Access Compliance Report

Public Rights-of-Way

(Curb Ramps)

Intersection ID: 29216	Main Street: BAUCOM_RD	Cross Street: BRATHAY_CT	Location: SW
ADA ID: 029D412FA9F4	Ramp Type: Perp	Initial Pass/Fail: Fail	Overall Compliance: No
Severity Score: 21.25			
Codes/Mitigation Info/Possible Solution		Field Measurements/Component Compliance

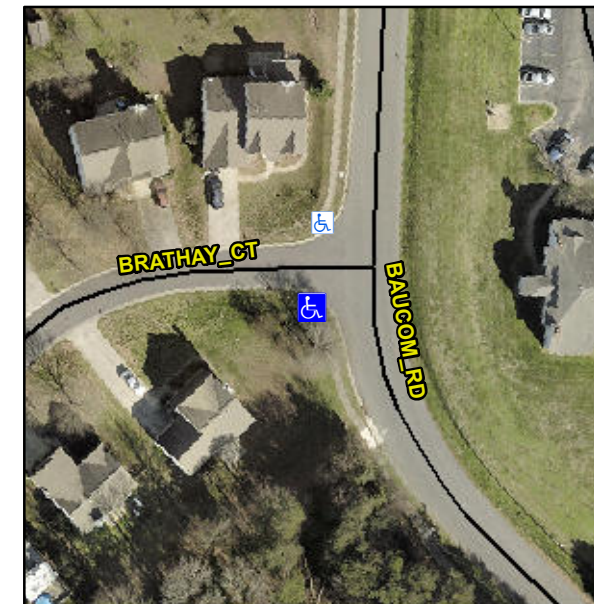
Not Found, R304.5.1, R304.5.3

Compliance	Description	Data	Compliance	Description	Data
N/A	Ramp Length (in)	45.5	Yes	Ramp Slope (%)	5.5
No	Ramp Width (in)	47.0	No	Ramp XSlope (%)	6.7
N/A	Flare Type LT	N/A	N/A	Flare Type RT	N/A
N/A	Flare Slope LT (%)	N/A	N/A	Flare Slope RT (%)	N/A
N/A	Flare Traversable LT?	N/A	N/A	Flare Traversable RT?	N/A
N/A	Landing Length (in)	N/A	N/A	DWS Provided?	N/A
N/A	Landing Width (in)	N/A	N/A	DWS Contrast?	N/A
N/A	Landing Slope (%)	N/A	N/A	DWS Length (in)	N/A
N/A	Landing X Slope (%)	N/A	N/A	DWS Full Width?	N/A
N/A	Landing Curb? (Y/N)	N/A	N/A	DWS Offset (in)	N/A
N/A	Shared Landing?	N/A			
N/A	Gutter Ponding?	N/A	N/A	Gutter Slope (%)	N/A
N/A	Gutter Lip Ht (in)	N/A	N/A	Gutter X Slope (%)	N/A
N/A	Painted X Walk1?	No	N/A	Painted X Walk2?	N/A
	X Walk 1 Direction	To N		X Walk 2 Direction	N/A
N/A	X Walk 1 Width (in)	N/A	N/A	X Walk 2 Width (in)	N/A
	X Walk 1 Slope (%)	3.1		X Walk 2 Slope (%)	N/A
	X Walk 1 X Slope (%)	7.1		X Walk 2 X Slope (%)	N/A

Remove & Replace Entire Ramp.
